**Supplemental Environmental Assessment of a
Marine Geophysical Survey by the R/V *Marcus G. Langseth*
in Southeast Asia, March–July 2009**

LGL Report TA4553-3

This Supplemental EA is in response to the comments received by NOAA through the public comment periods associated with the IHA process. NSF received no direct public comments on the draft EA during (or after) the open comment period of 14 November 2008 through 15 December 2008. Included are a number of changes to the survey design that were made by L-DEO to address specific comments, some received by a number of individuals and agencies, and to enhance measures already included in the original documents to mitigate effects of the proposed survey on marine mammals

FIGURE 1. Study area and proposed seismic transect lines for the TAIGER survey in SE Asia, revised based on public comments submitted to NMFS. Different colored lines correspond to the various legs of the cruise [see text]. Leg 3 is not shown as it does not involve seismic acquisition.

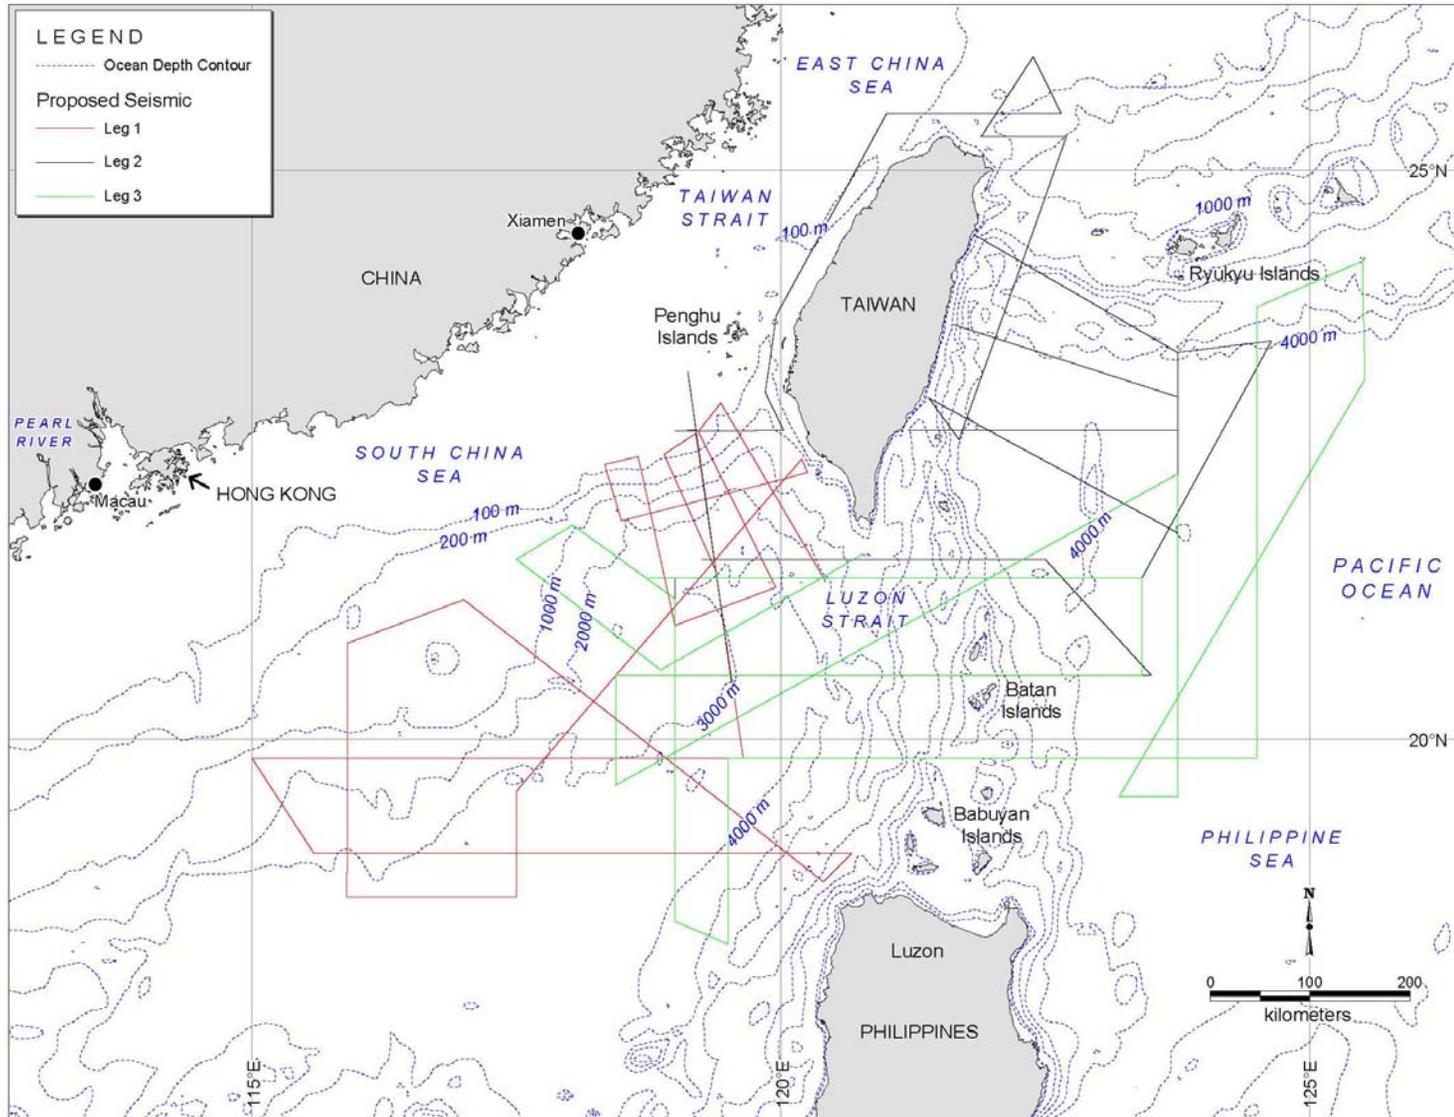
Many of the comments, including some of those from the Eastern Taiwan Strait Technical Advisory Working Group (ETSSTAWG), the Hong Kong Dolphin and Conservation Society (HKDCS), Humane Society International (HSI), Dr. John Wang (JW), the Natural Resources Defense Council (NRDC), and Wild at Heart (WAH), concerned possible effects of the seismic surveys on the small population of ~100 Indo-Pacific humpback dolphins (*Sousa chinensis*) that occurs along a ~100 km stretch of the west coast of Taiwan, from Taixi to Tongshiao (Wang et al. 2007). That population, the Eastern Taiwan Strait subpopulation, is considered Critically Endangered on the IUCN Red List of Threatened Species (IUCN 2008). The shallow waters off the west coast of Taiwan are also inhabited by the finless porpoise (*Neophocaena phocaenoides*), considered Vulnerable by IUCN (2008).

Other comments expressed concern about the mainland side of Taiwan Strait and shallow waters of the South China Sea. The Jiulong River Estuary, on the mainland side of Taiwan Strait at ~24.5°N, is habitat for another subpopulation of ~90 *Indo-Pacific humpbacked dolphins* (Chen et al. 2008 in JW comments). Winter breeding grounds of the *western gray whale* are not known, but are thought to be located in the South China Sea, along the coast of Guangdong province and Hainan (Wang 1984 and Zhu 1998 in Weller et al. 2002a; Rice 1998). Also, the migration route of the gray whale is ill defined, but very likely extends through Taiwanese waters, probably through the Taiwan Strait. Their occurrence there is possible from December to April. If migration timing is similar to that of the better-known eastern gray whale through similar latitudes, southbound migration probably occurs mainly in December–January, and northbound migration mainly in February–April, with northbound migration of newborn calves and their mothers probably concentrated toward the end of that period. Even during migration, gray whales are found primarily in shallow coastal waters. Shallow, coastal waters of the South China Sea are also inhabited by one of the three populations of the *finless porpoise*.

Other concerns were expressed about the survey line that was parallel to and within a few km of the east coast of Taiwan because of potential effects on coastal species and those that frequent the shelf break and steep slopes, e.g., beaked and sperm whales. The continental shelf is narrow there (Fig. 1).

Another concern was raised in several comments (JW, NRDC) about survey lines scheduled for Leg 2 (20 April to 7 June) approaching humpback whale breeding areas in the Babuyan and Ryukyu Islands. In fact, the humpback whales that winter and calve in the Ryukyu Islands are near Okinawa (Nishiwaki 1959; Rice 1989; Darling and Mori 1993), some 400 km north of the most northerly survey. However, a small population of humpbacks does winter and calve in the Babuyan Islands in Luzon Strait (Acebes and Lesaca 2003; Acebes et al. 2007). The whales may arrive in the area as early as November and leave in May or even June, with peak occurrence during February through March or April (Acebes et al. 2007).

L-DEO has negotiated with the project's principal scientists to modify the cruise plan and adopt more precautionary mitigation measures. Off Taiwan's west coast, the cruise tracks have been re-routed offshore by ~20 km to protect the critically endangered *Sousa* population and the finless porpoise, as well as ease potential pressure on other coastal species (Fig. 1). Thus, it is now planned to maintain the precautionary buffer recommended by ETSSTAWG in their comments to NMFS, "at least 13 km and perhaps a more precautionary 15 km of the ETS *Sousa* population—meaning up to around 20 km from shore".

Because of these concerns about effects of the proposed surveys on gray whales, Indo-Pacific humpbacked dolphins, and finless porpoises, the proposed survey lines in the South China Sea south of the Taiwan Strait have been re-routed so that they are now located in water depths >200 m, as recommended by NRDC. The seismic lines in western Taiwan Strait have been dropped (Fig. 1).

The proposed survey line paralleling the east coast of Taiwan has also been moved offshore by more than 20 km to decrease potential impacts on species that occur in coastal waters and over the continental slope (Fig. 1).

To mitigate against the potential effects of the surveys on humpbacks, particularly mothers and calves on the breeding grounds or during the beginning of migration to summer feeding grounds, the surveys that approach the Babuyan Islands have been rescheduled as late as possible, to Leg 4 (18 June–20 July).
